# Access Compliance Report

## Public Rights-of-Way

### (Pedestrian Signals)

Intersection ID: N/A	Main Street:	Cross Street: N/A	Location: N/A
ADA ID: 22C47F778FC7	Signal Type: One Push Button-Non APS	Overall Compliance: No	Severity Score: BTN 1: N/A BTN 2: N/A No BTN: N/A
Codes/Mitigation Info/Possible Solution		Field Measurements/Component Compliance

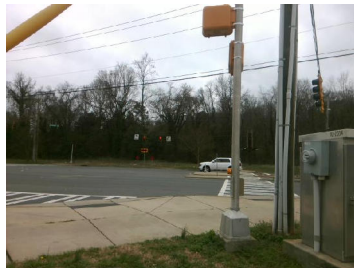
PROW/ADA: TMUTCD 4e.08, R404.2, R404.7.3, R404.7.2

Possible Solutions: Replace Signal Push Button With APS Button on New Post. Remove & Relocate Sign.
